Brookhurst Street/ Adams Avenue Intersection Improvements Project ENVIRONMENTAL IMPACT REPORT

**FINAL
ENVIRONMENTAL IMPACT REPORT**

**BROOKHURST STREET/
ADAMS AVENUE INTERSECTION
IMPROVEMENTS PROJECT**

2.0 RESPONSE TO COMMENTS

ATTACHMENT A
REVISED EXHIBIT 7-1B OF THE DRAFT EIR
REDUCED RIGHT-OF-WAY ALTERNATIVE

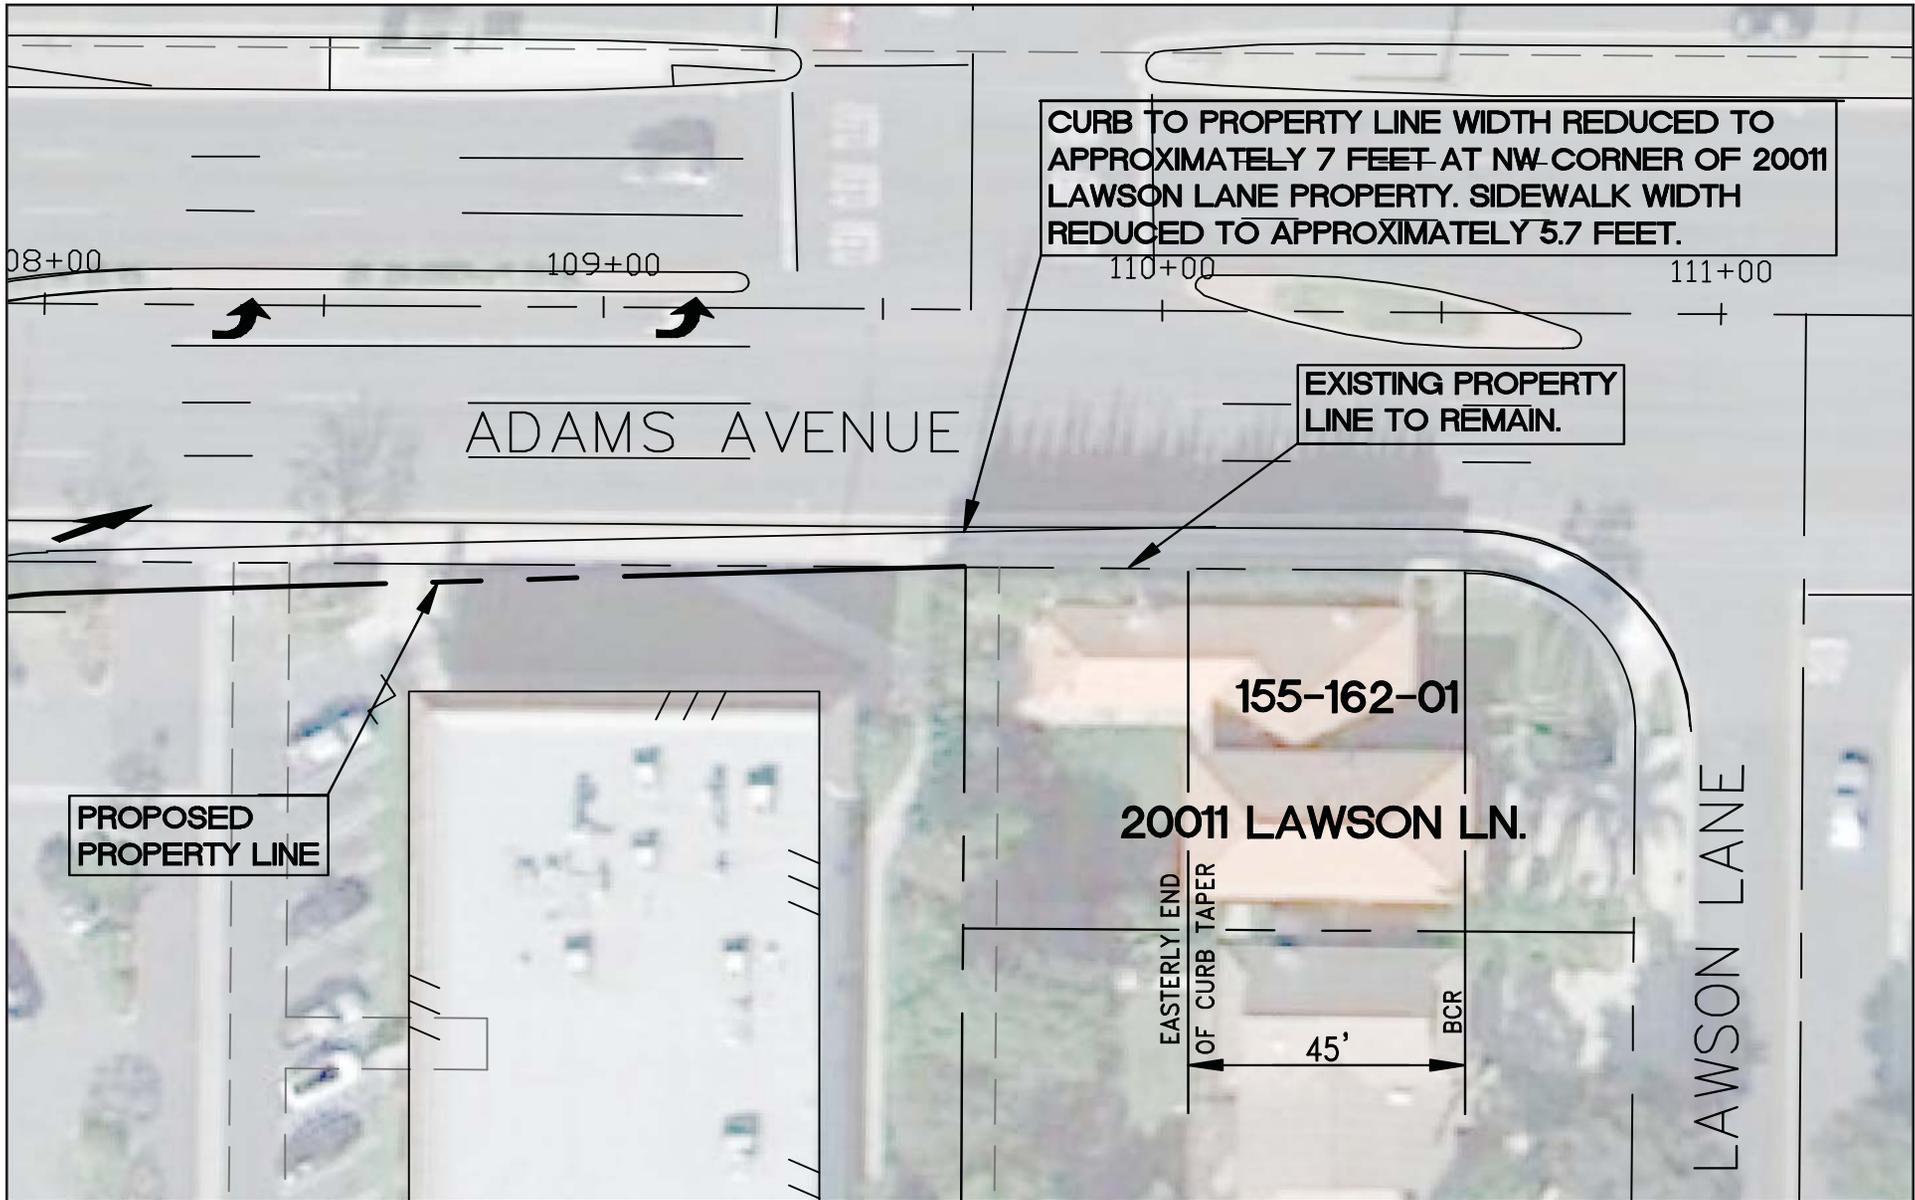
- 10-1 This comment includes concerns related to traffic safety in addition to an overview of improvements under the “Reduced Right-of-Way” Alternative. Refer to Topical Response A pertaining to traffic safety concerns within Section 2.1, *Topical Responses*.
- 10-2 Based on additional field verification performed by the City, Draft EIR page 7-6 would be revised in the Final EIR, as follows:

Exhibit 7-1b, *Reduced ROW Alternative*, of the Draft EIR, would also be revised in the Final EIR and has been included as Attachment A of this Response to Comments document.

Note that Exhibit 7-1b has been revised as shown within Attachment A of the Responses to Comments.
